Planning Commission MEETING AGENDA

Thursday, March 21, 2024 - 1:00 PM
Council Chambers, Easton Town Office
14 S Harrison Street

DATE: February 26th, 2024
TO: John Wooters – Applicant
Cc: Rick Van Emburgh – Town Engineer
Aaron Goller – EUC
Miguel Salinas - Planning and Zoning
FROM: Sierra Clem – Engineering Department
SUBJECT: 7365 Brett Road - Stream Buffer Review

**PLANNING COMMISSION
PUBLIC HEARING
STAFF REPORT**

DATE: 02-08-23
DRAWN BY: [] CHECKED BY: []
REVISION DATES:
07/21/23 [] [] []
09/27/23 [] [] []
01/05/24 [] [] []
03/01/24 [] [] []
SHEET NUMBER: []
JOB NUMBER: []
DRAWING NUMBER:
A100

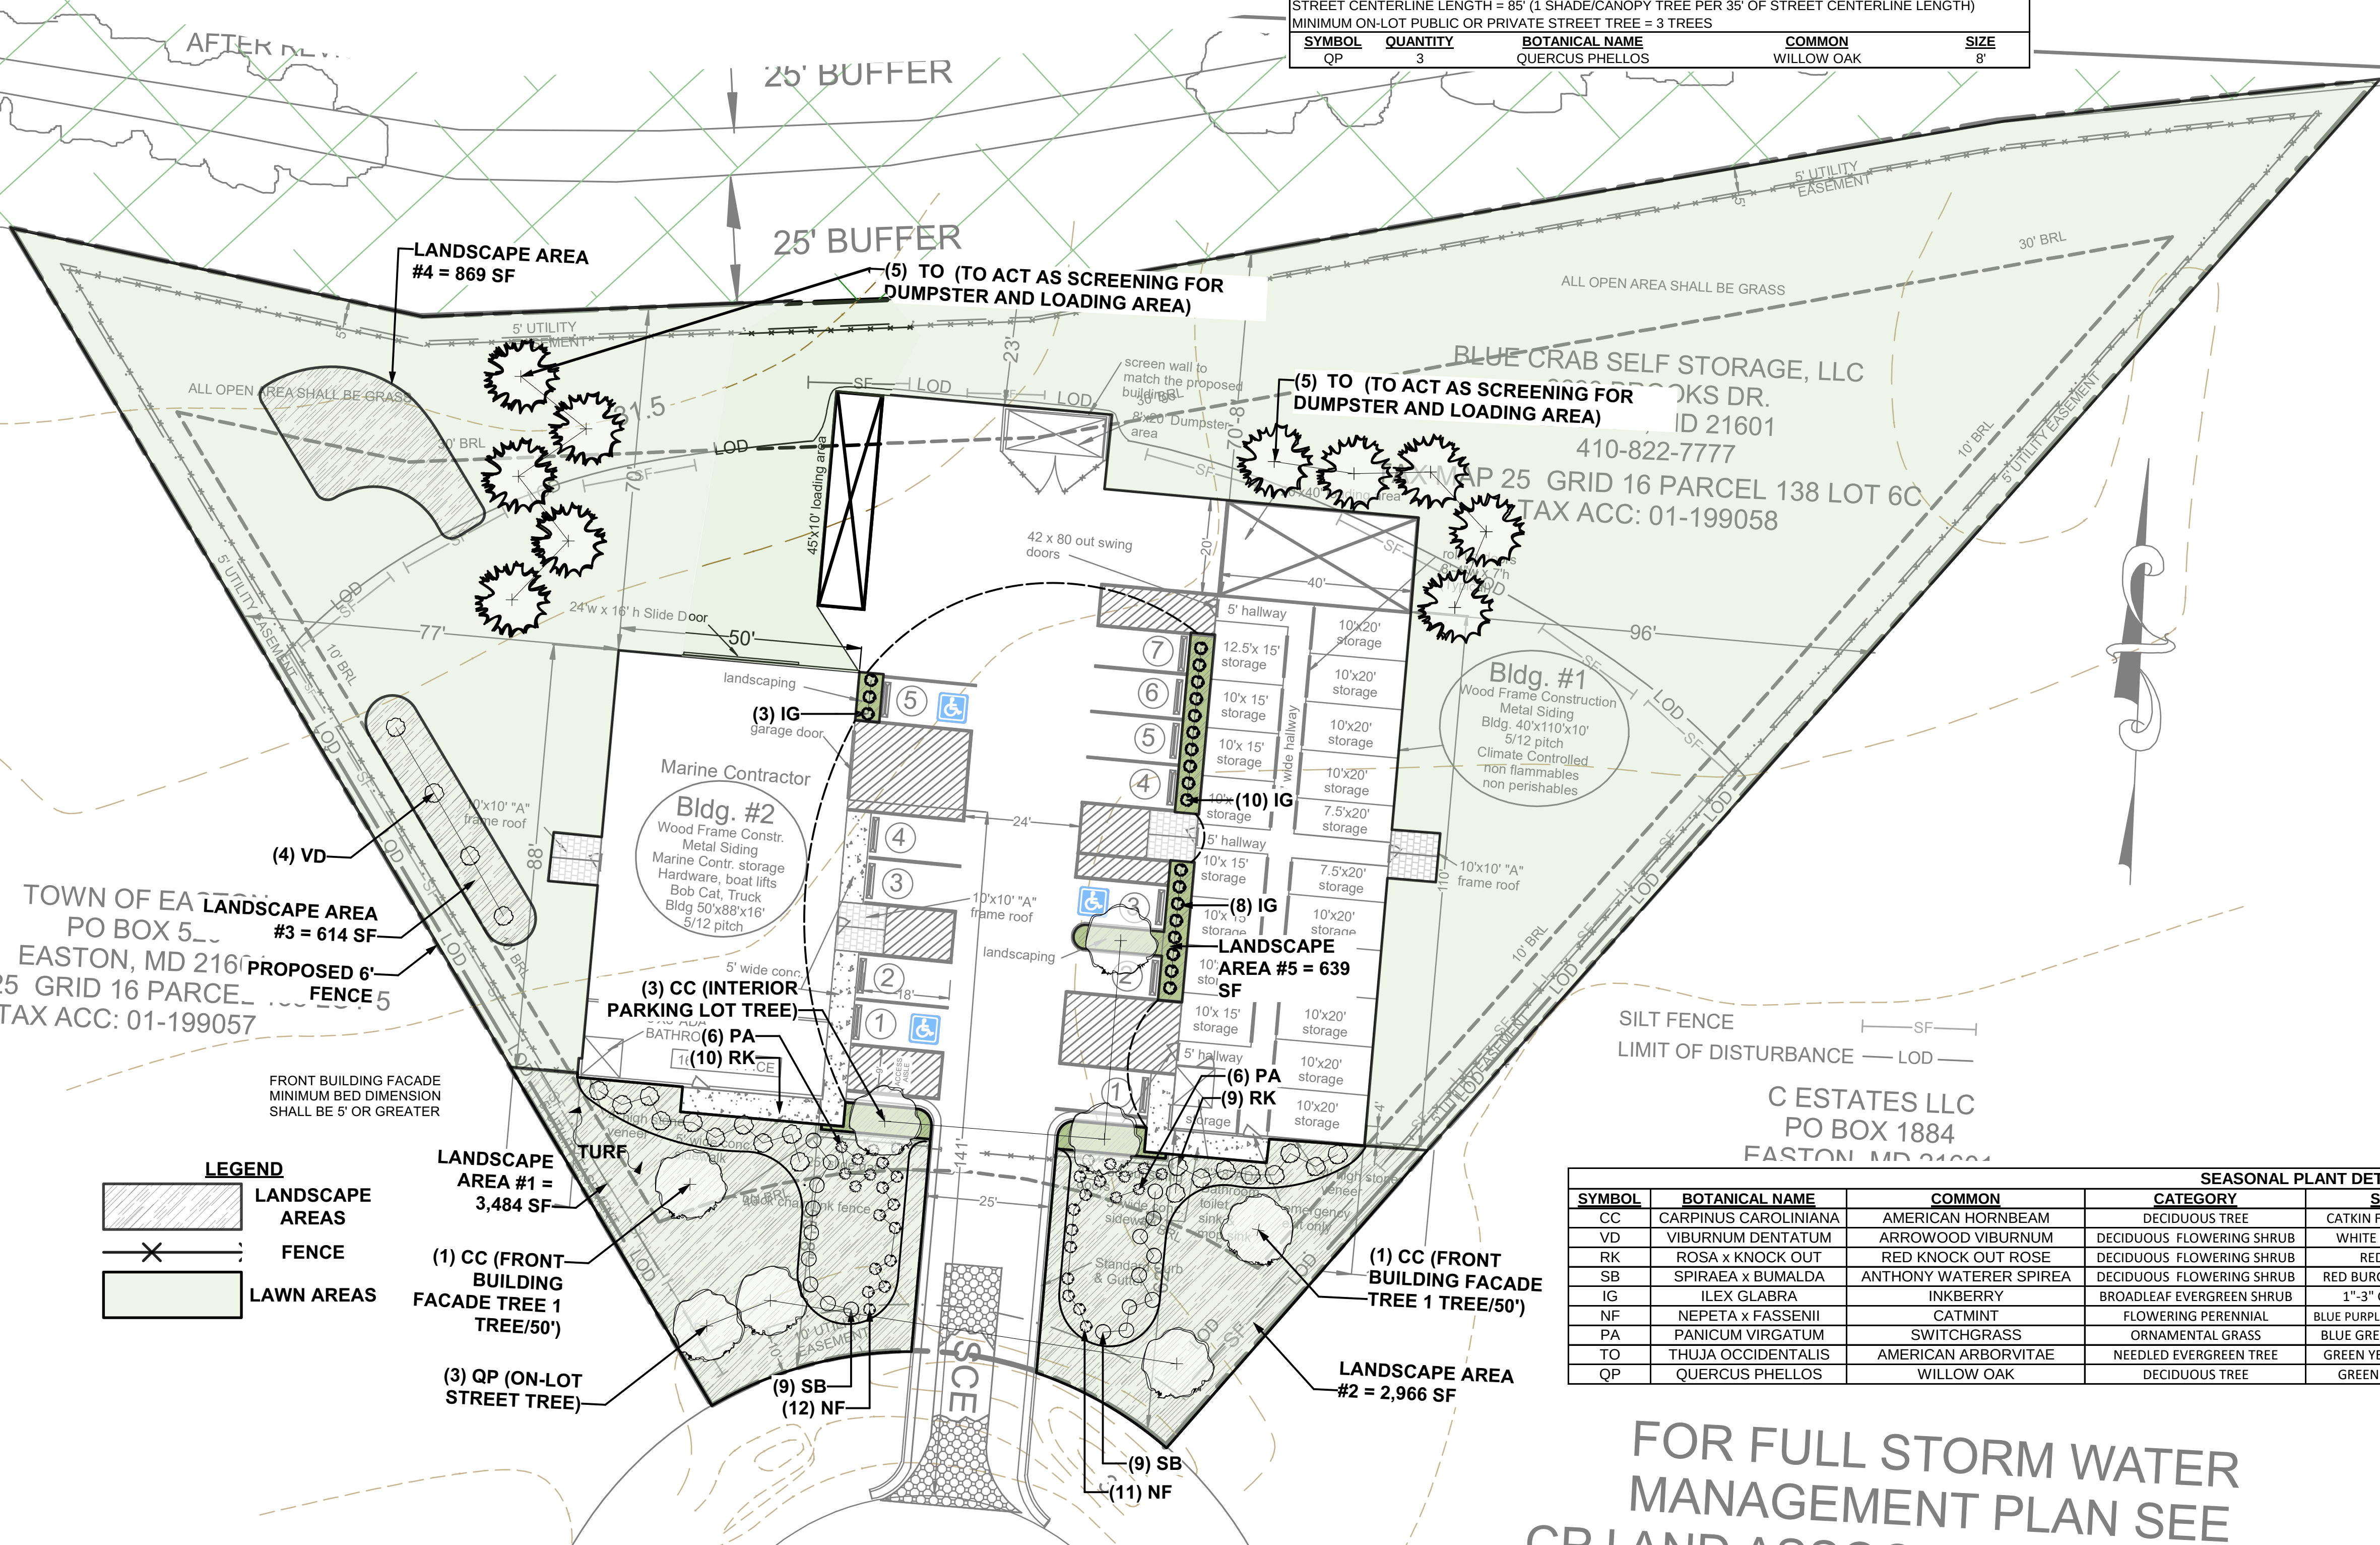
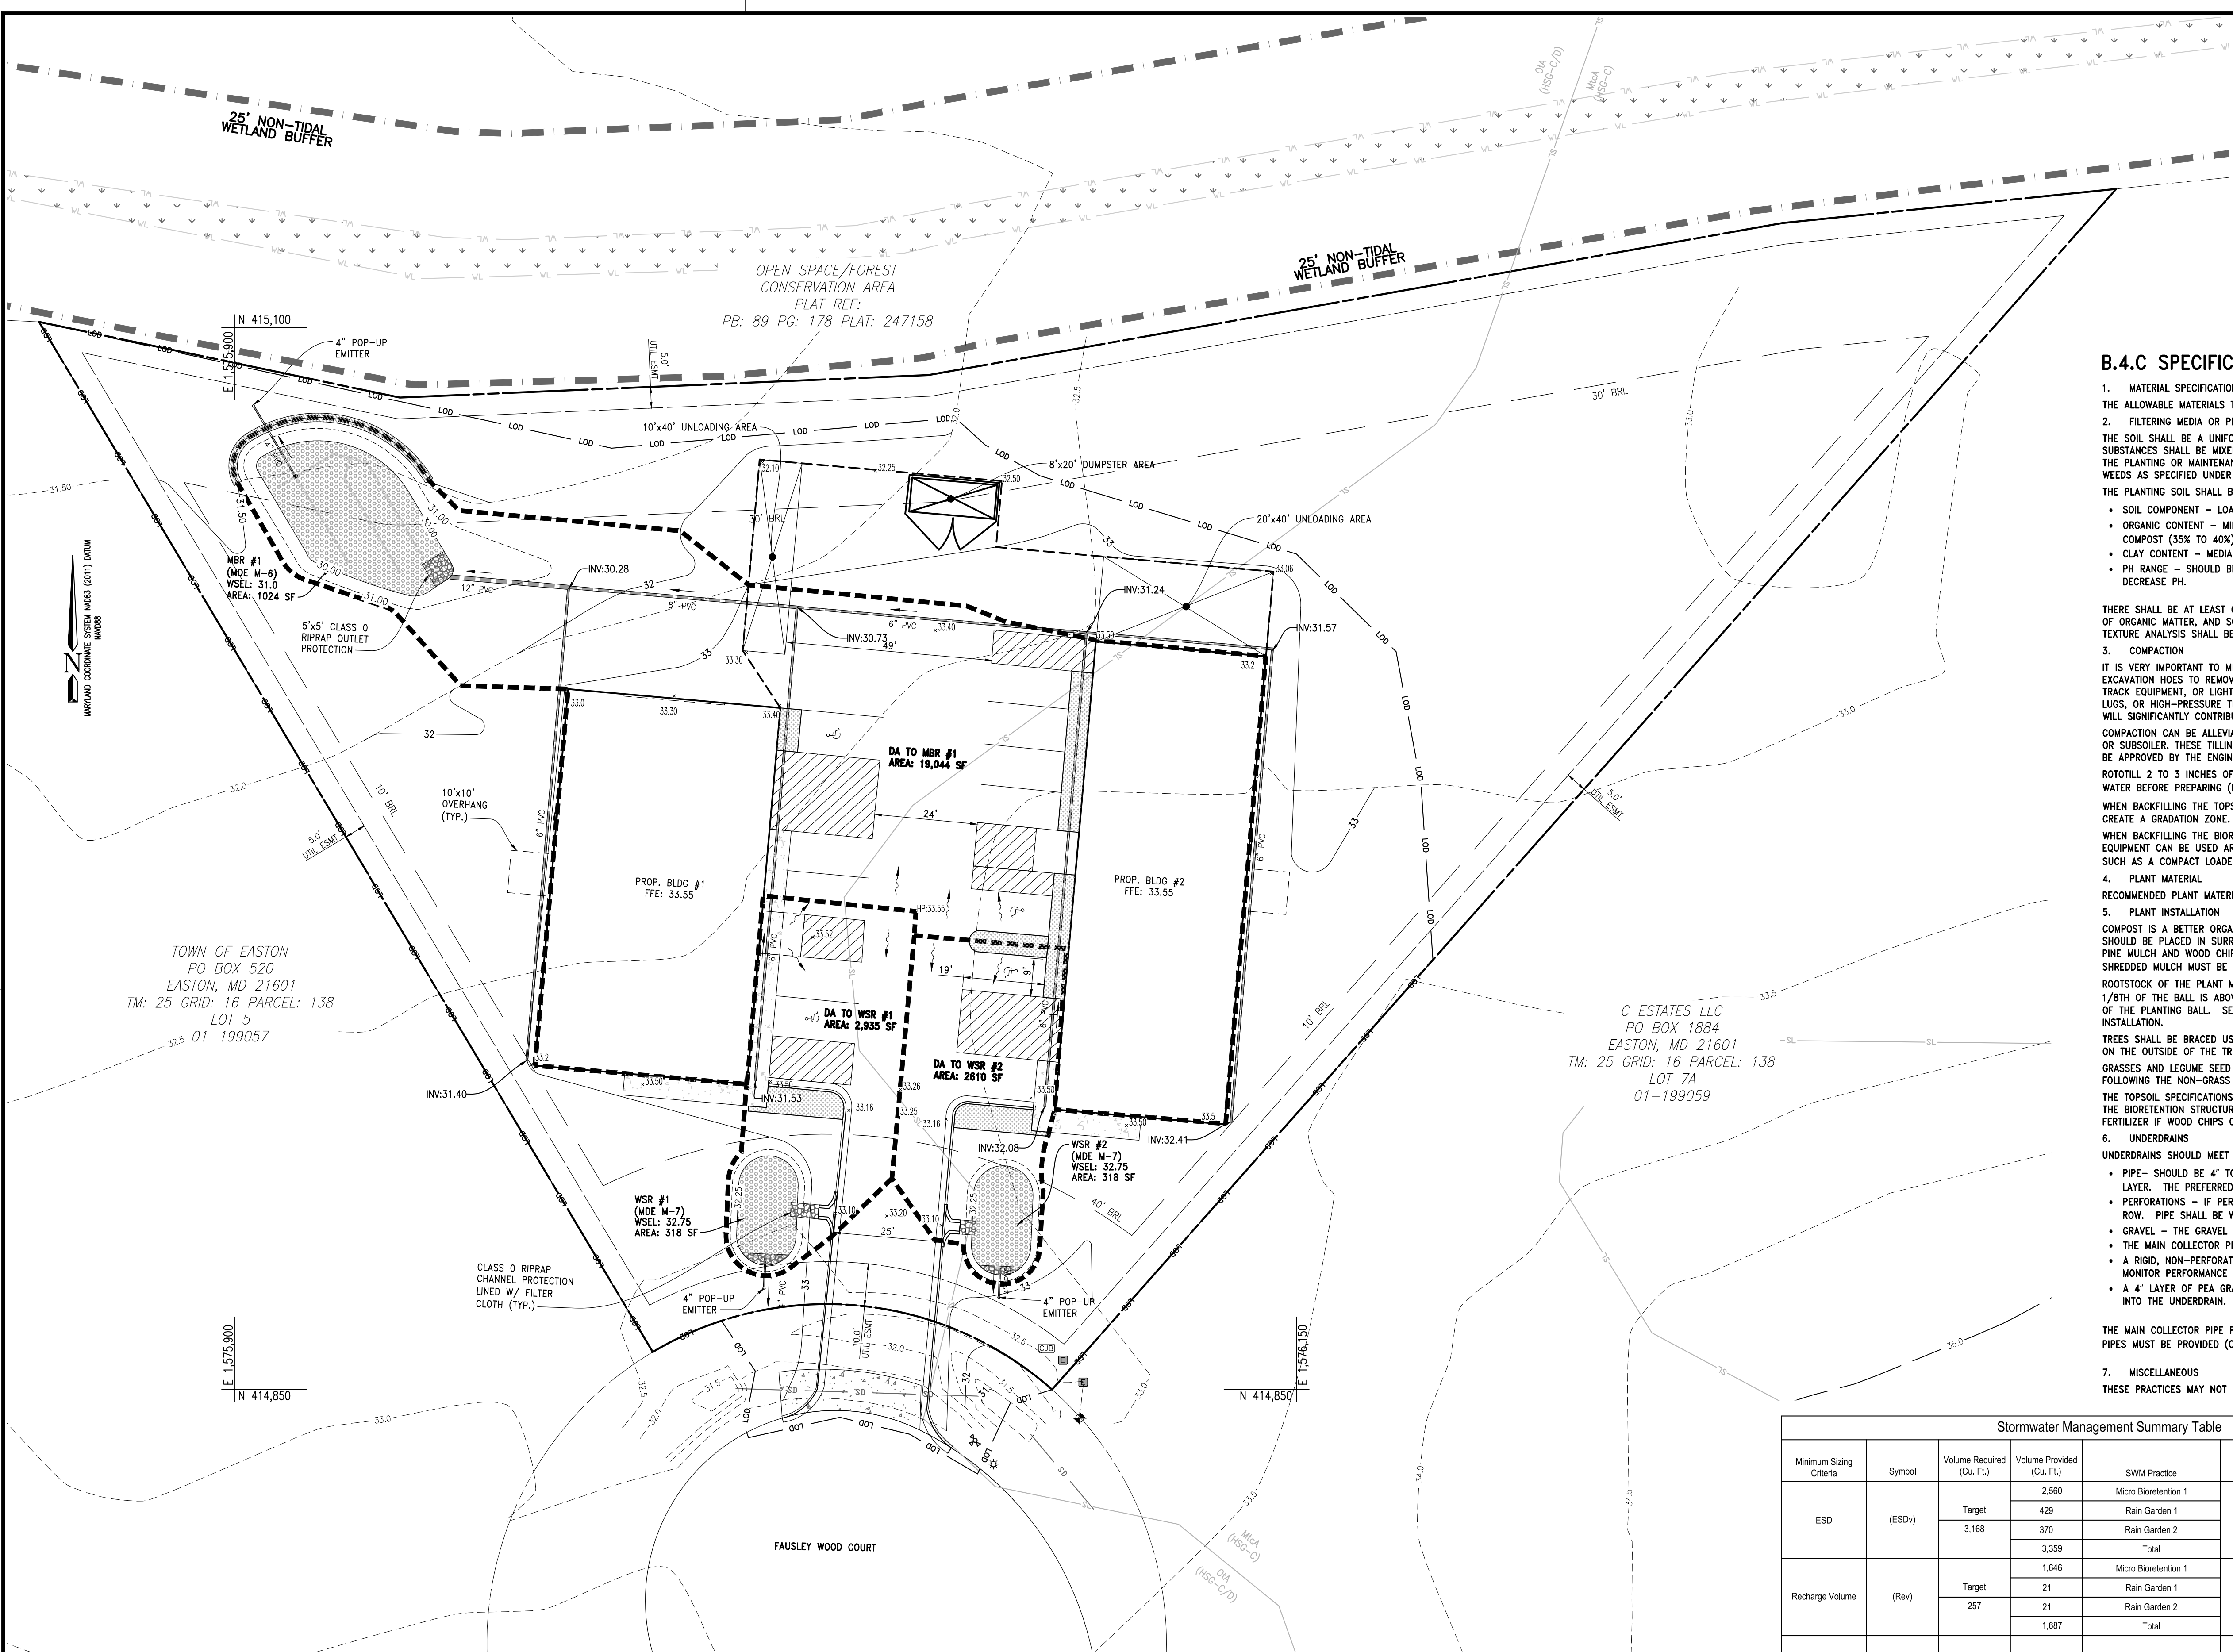
3. Please revise the Landscape Plan and Tabulations on sheet A100. to replace Green Giant Arborvitae with an native plant species such as American Arborvitae.

4. Revise Landscape Tabulations on sheet A100 to include components reflecting seasonal changes in the plans.
5. Add notes to General Notes on sheet 1 to read: *"Lighting sources screened from view or directed downward and shielded"* and *"Automobile and truck parking areas, if illuminated, shall be directed downward and screened to reduce visible glare from the street."*
